**TOWN OF BLIND RIVER
REQUEST FOR TENDER
NEW BLIND RIVER WATER TREATMENT PLANT INTAKE AND LOW LIFT PUMPING STATION
CONTRACT NO. PS-2026-01**

**ADDENDUM #9
March 13th, 2026**

DRAWING TITLE:
PROPOSED ELECTRICAL SITE PLAN

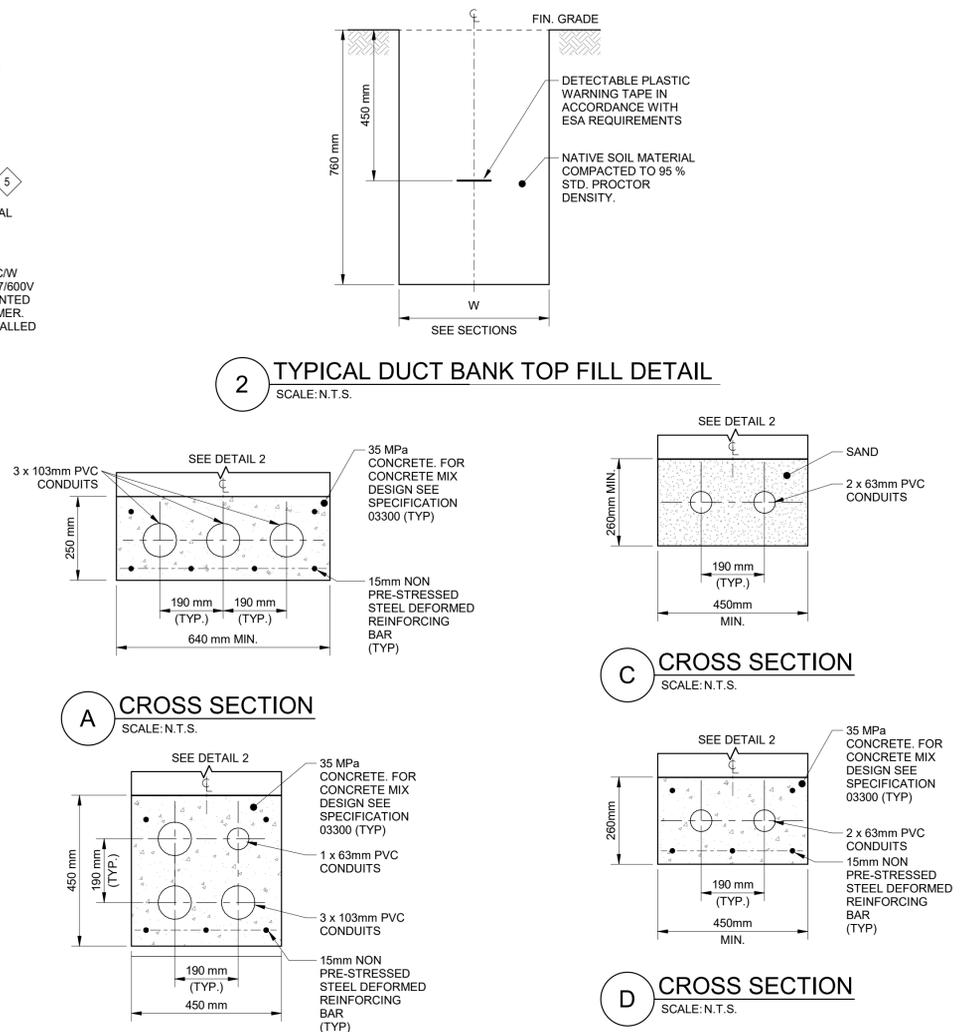
Q124: E102A- conduit run C3B states to install new pull box 2. Drawings shows PB3 from PB2 to MH4 but MH4 isn't located nor is there a detail or sizing requirements for MH4. Please confirm

A124: Manhole MH-4 is not required. A pull box located at the exterior wall of the new pumping station is acceptable. Refer to Change 4.10.

FIBER OPTIC CABLE INSTALLATION SITE PLAN

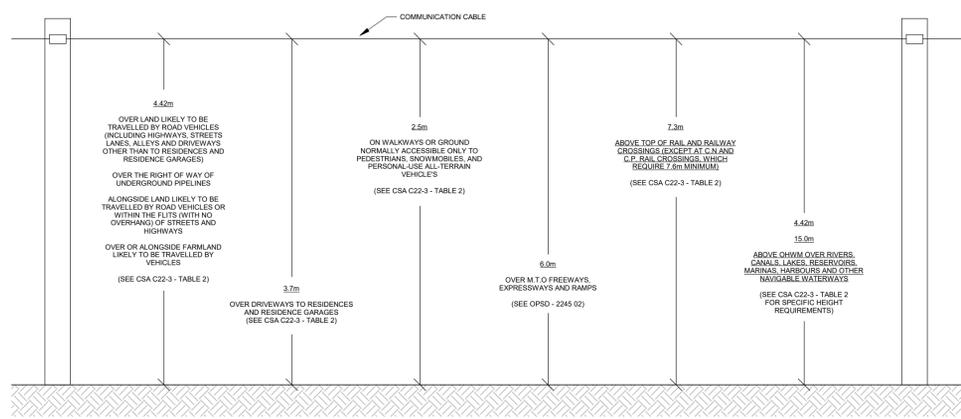
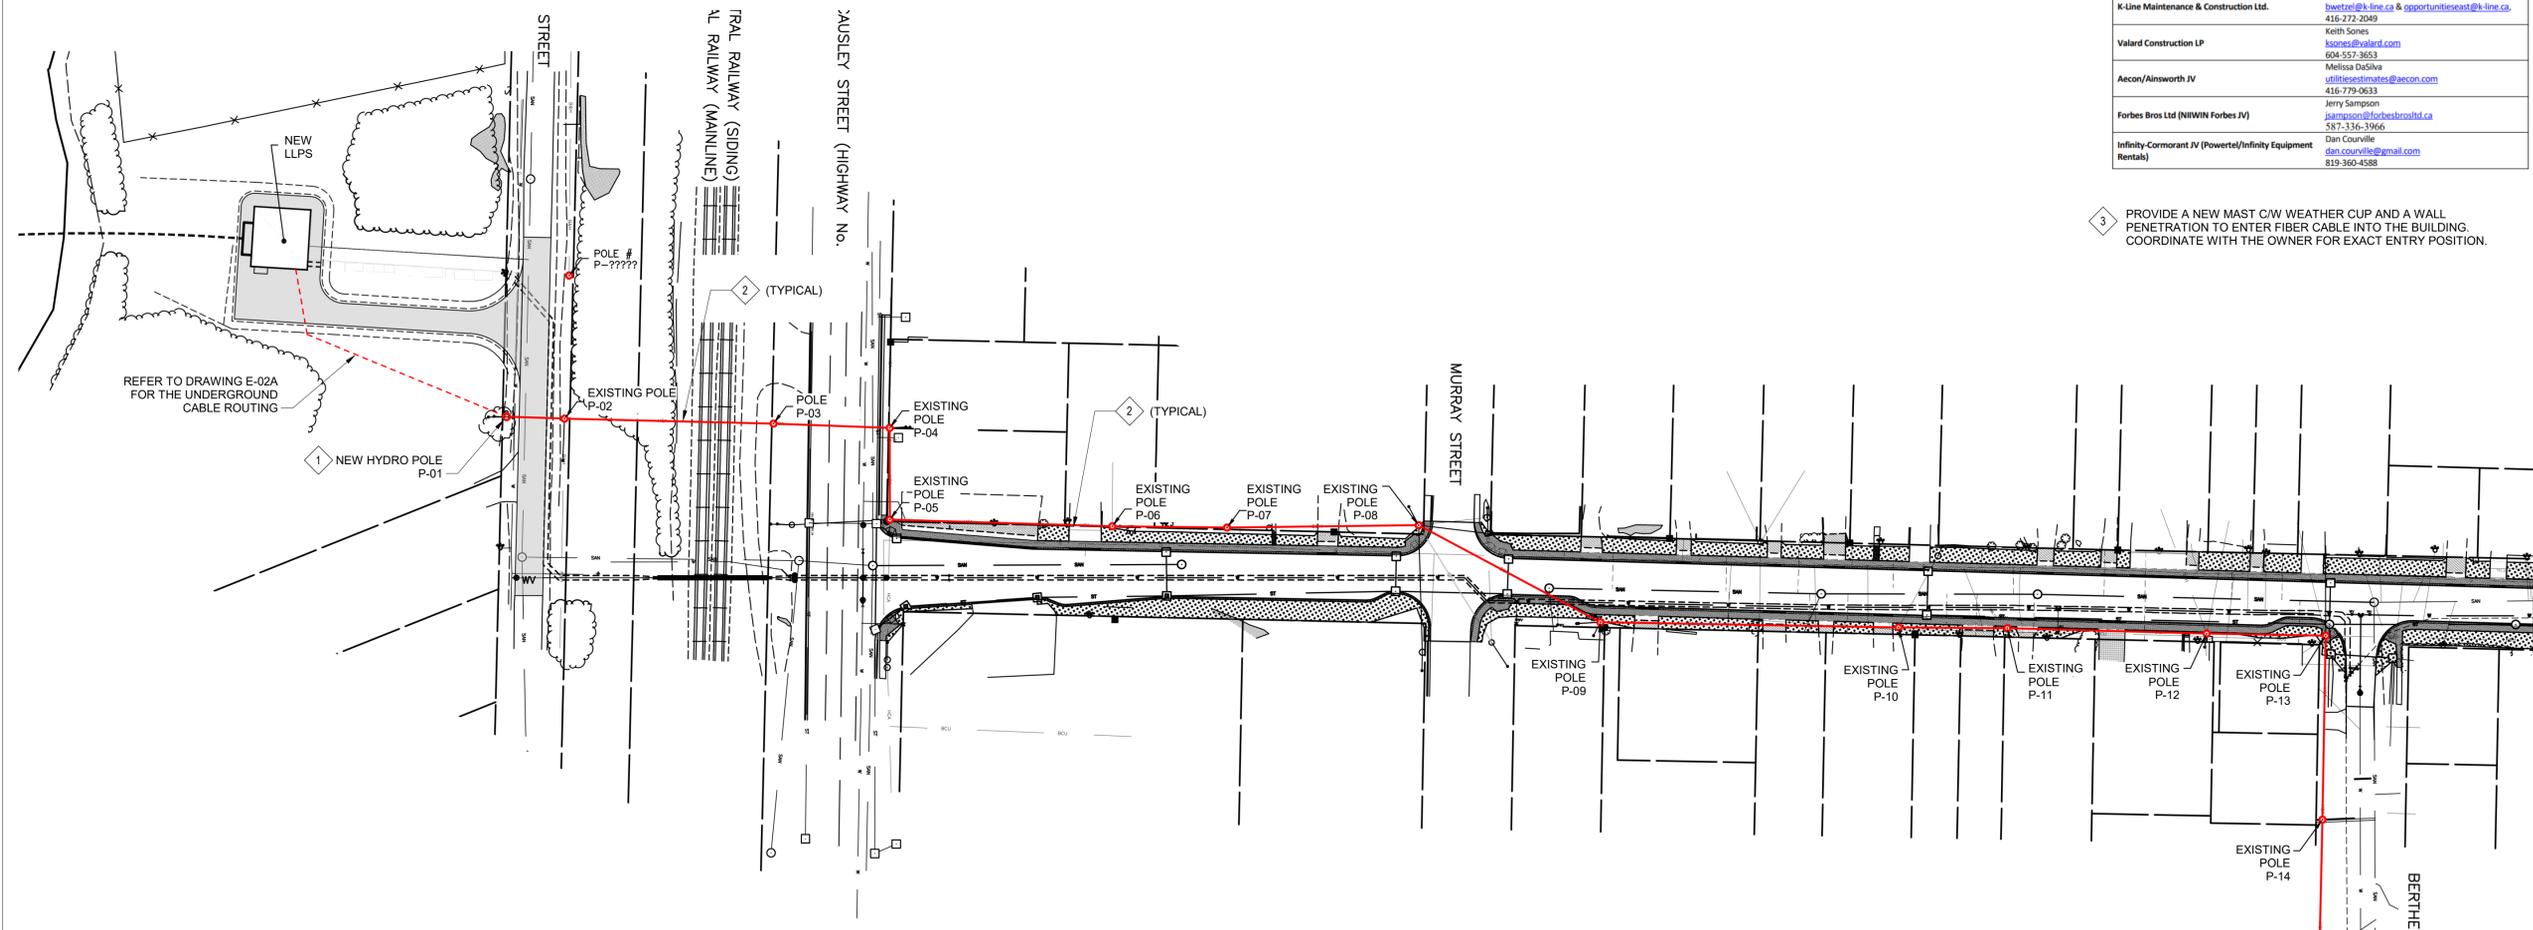
- Q26: Drawing E-102B specifies 12-strand OM3 multimode fiber, while drawing I-603 indicates 12-strand single mode fiber trunk cable. Please confirm which fiber type is required for the WTP to LLP connection.**

- A26: Fiber type for interconnection between the Water Treatment Plant and the new Low Lift Pumping Station shall be a 12-strand OS2 singlemode fiber trunk cable suitable for aerial installation as specified in Section 13590, Clause 2.2. Refer to Change 4.4 for updated drawing E-102B.

DRAWING TITLE:
ELECTRICAL CABLE TRAY & CONDUIT LAYOUT

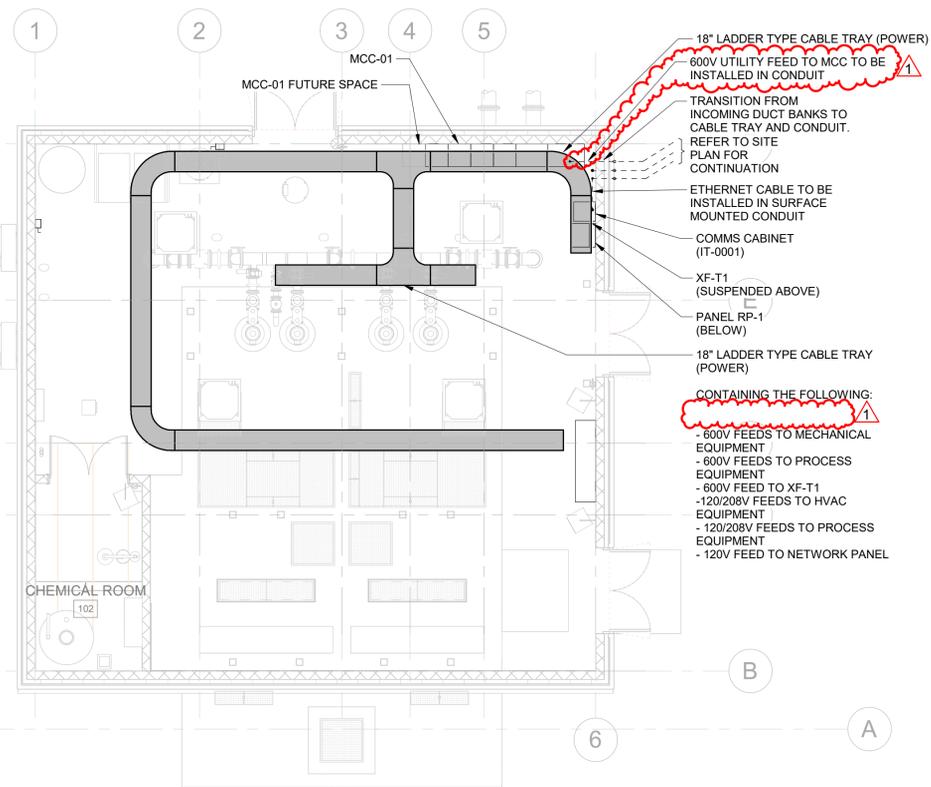
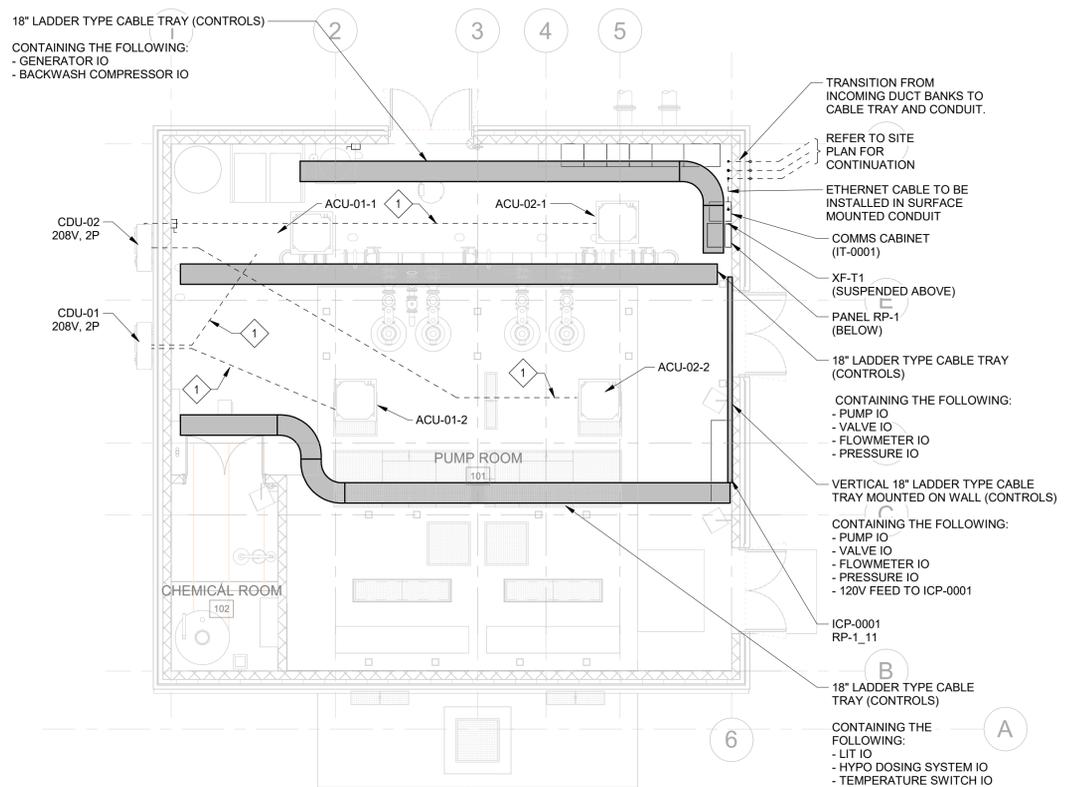
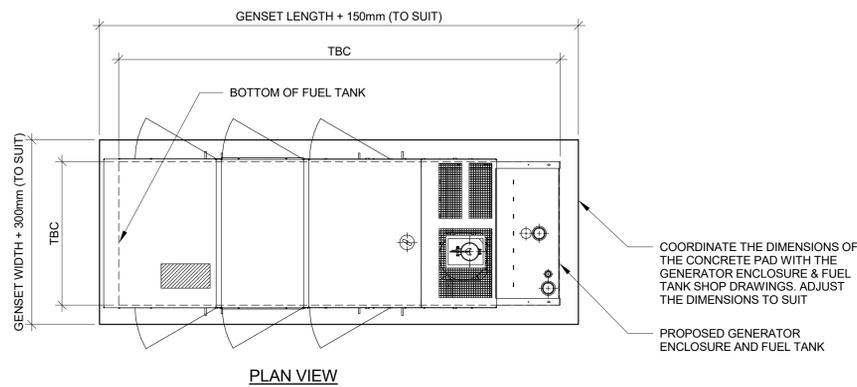
Q125: E601 note 3 states to use RWU for the main feeder than transition to a jbox on the wall and run into cable tray, per detail 1 on E103. Please provide clarification on the transition methods

A125: Provide four (4) 1C-3/0 RWU90 conductors installed in a dedicated 103 mmC surface-mounted PVC conduit routed to the MCC Service Entrance Section (Refer to Change 4.11).

ELECTRICAL DETAILS - SHEET 1

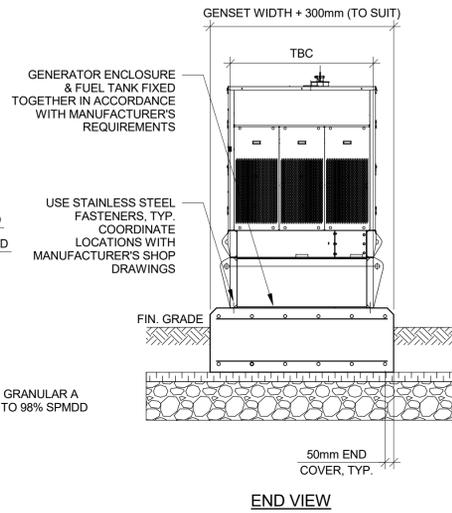
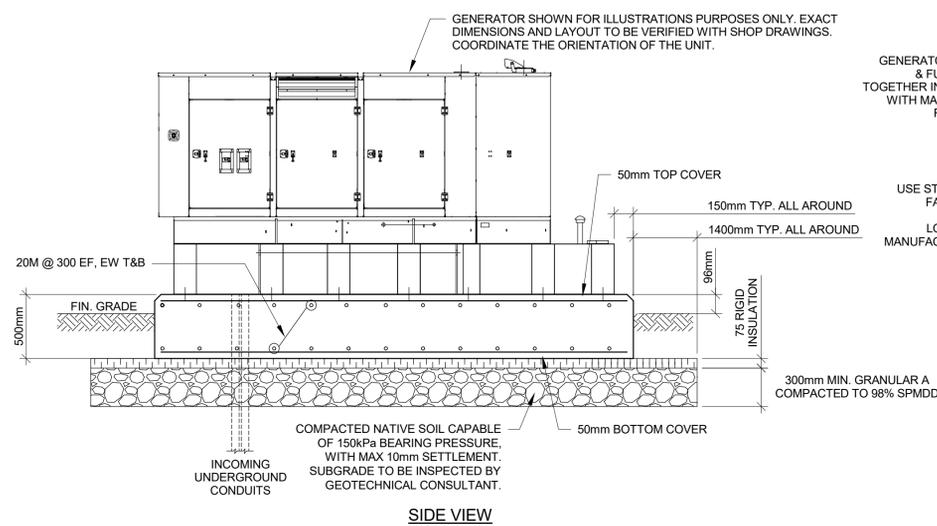
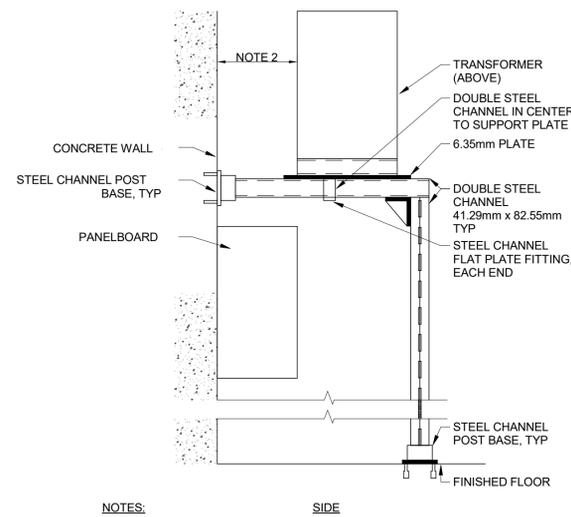
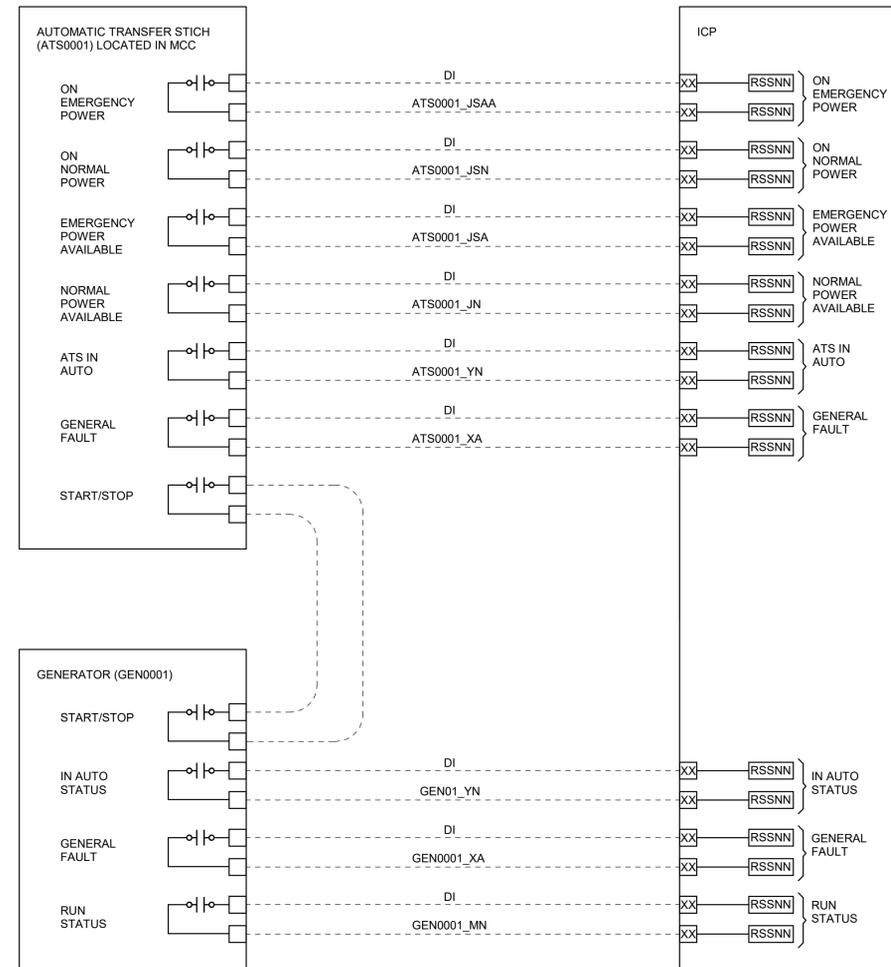
- Q51: Addendum #8, Q5 – This response does not fully answer the question being asked, as an alternate is not being proposed. We just need to confirm what kW size generator is required due to multiple kW ratings throughout the specs and drawings. Prime rating is not required on water station applications that are for emergency standby only. Drawing E-503, Note 1 states the generator is based on a 135kW prime rated unit, Section 16231 (2.2.1.1) asks for a 150kW standby rated generator, but the SLD asks for 150kW prime rated generator. Is a 175kW standby/160kW prime rating or a 150kW Standby/135kW prime rating generator required?**
A51: A 175 kW standby / 150 kW prime rated generator is required. Refer to Changes 3.19 and 4.7.

1 SINGLE LINE DIAGRAM
SCALE: N.T.S.

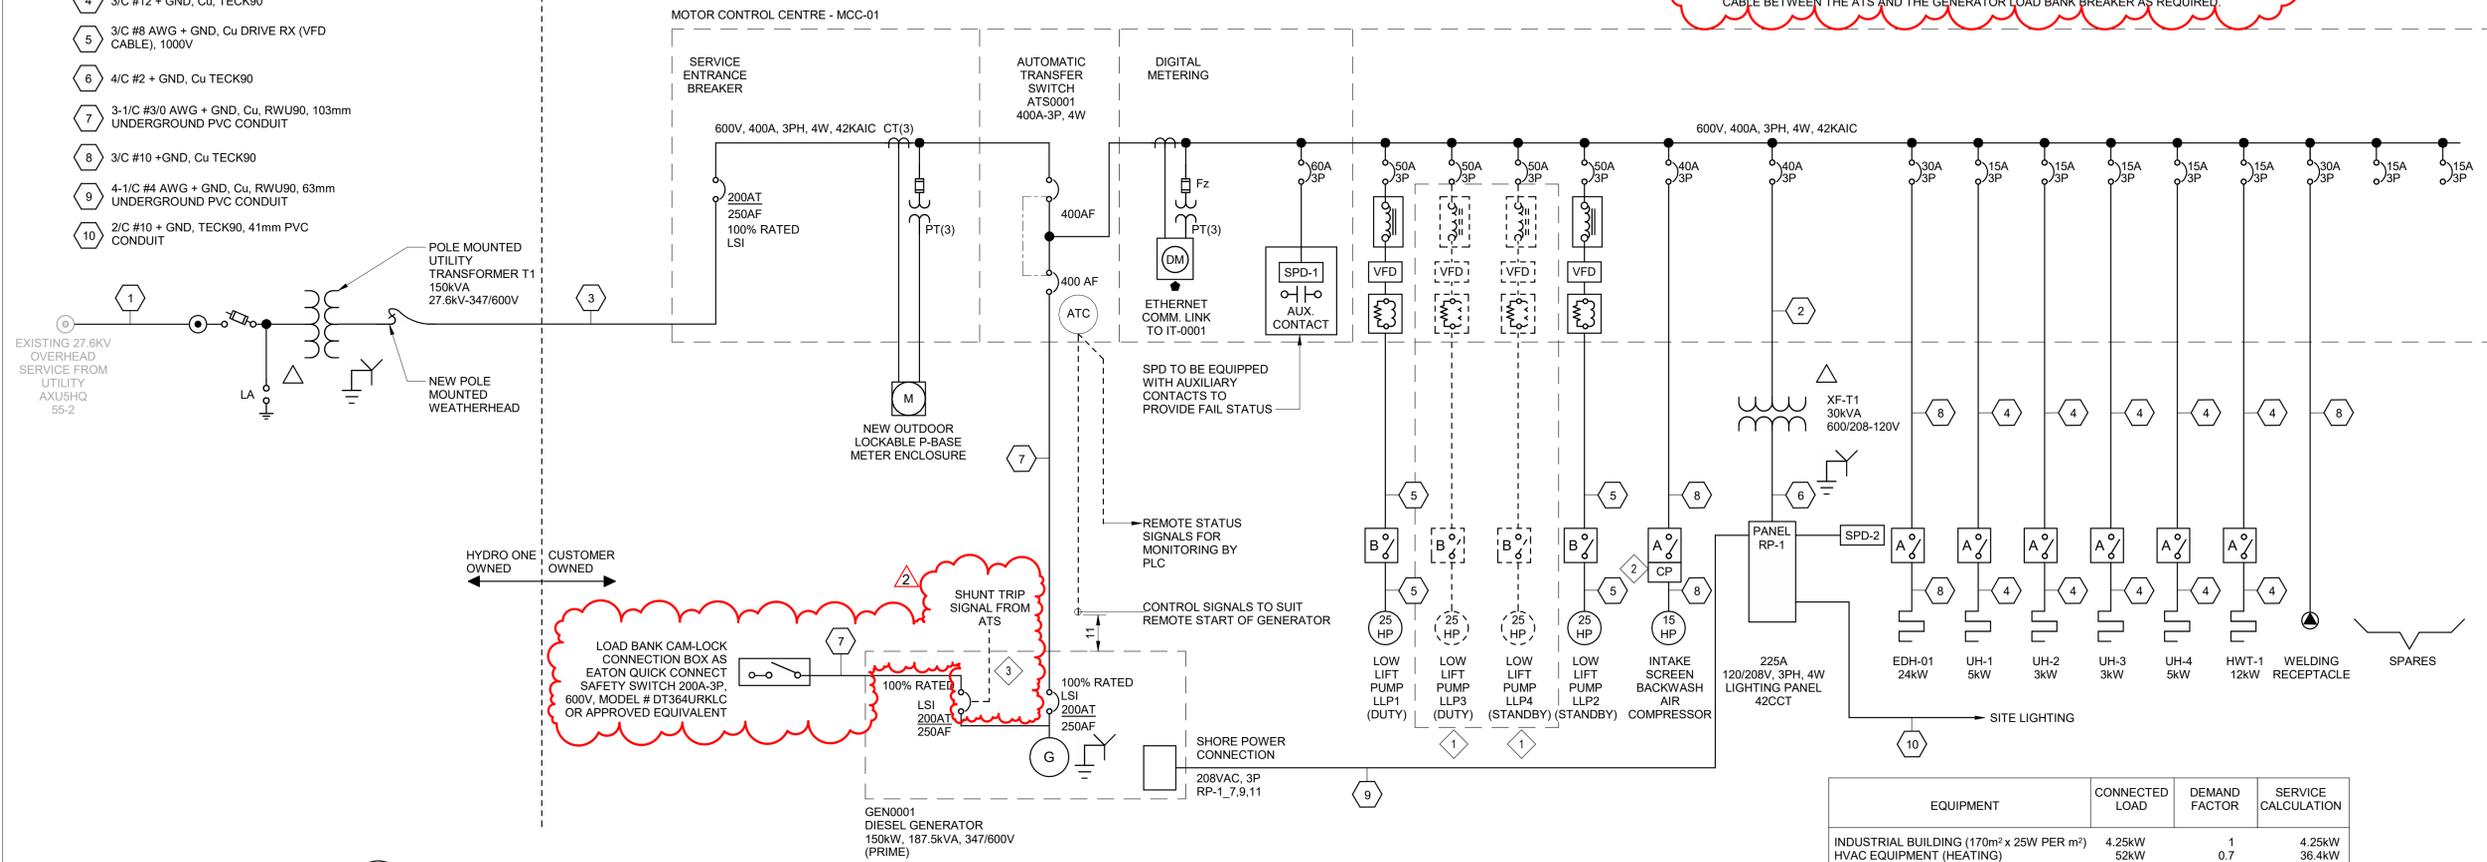
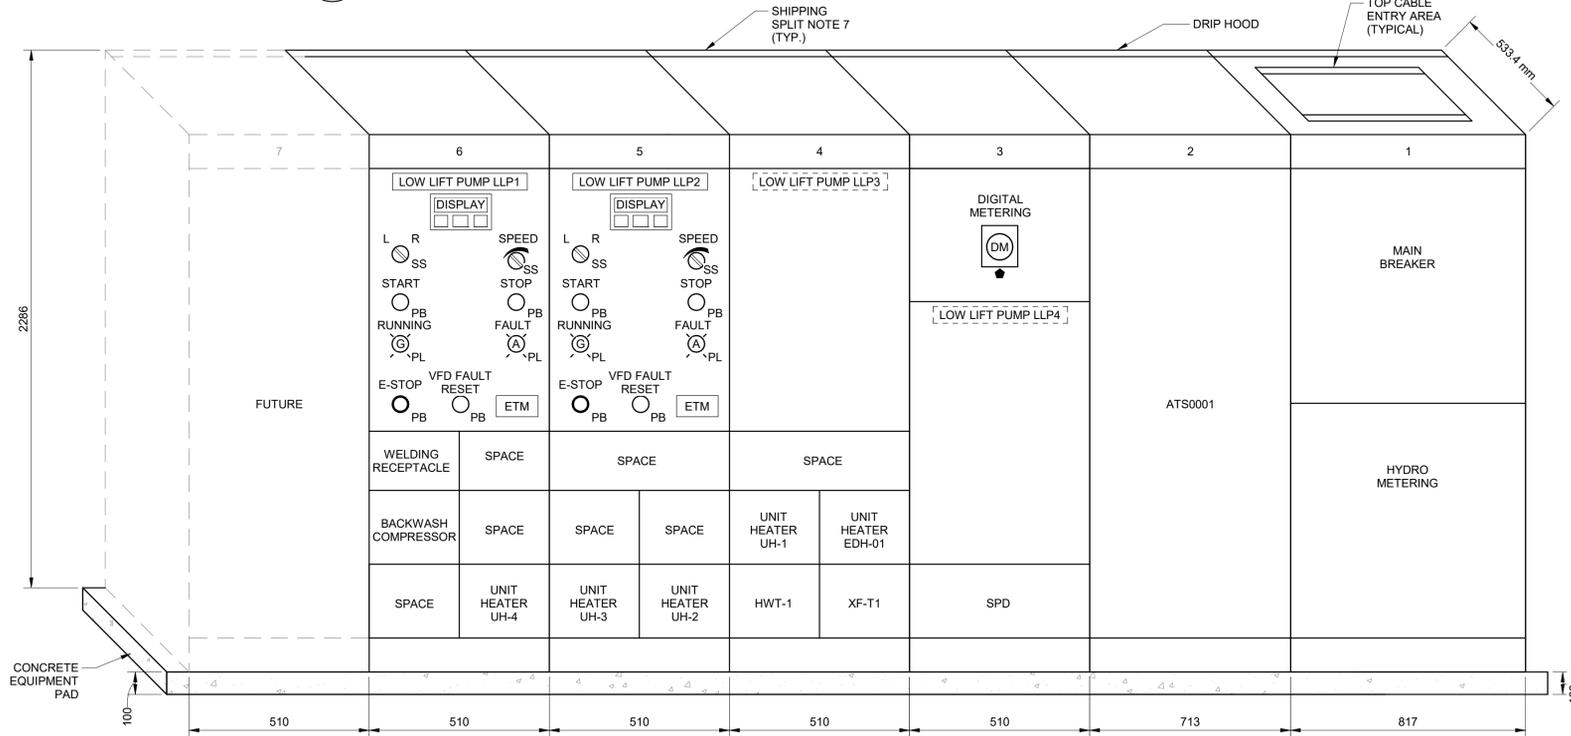
- Q50: E-601, Note 3 – Please advise if a kirk-key system is required. A practical design feature is to have the main breaker closed and shunt tripping the load bank breaker in case of a power failure during load bank testing. This way the generator is ready to provide power to the building within a short period of time vs having to deal with a kirk-key system to restore power to the building.**
A50: Contractor shall include a shunt trip to the load bank breaker, interlocked with the ATS. Refer to Changes 3.16, 3.17, 3.18, and 4.3.
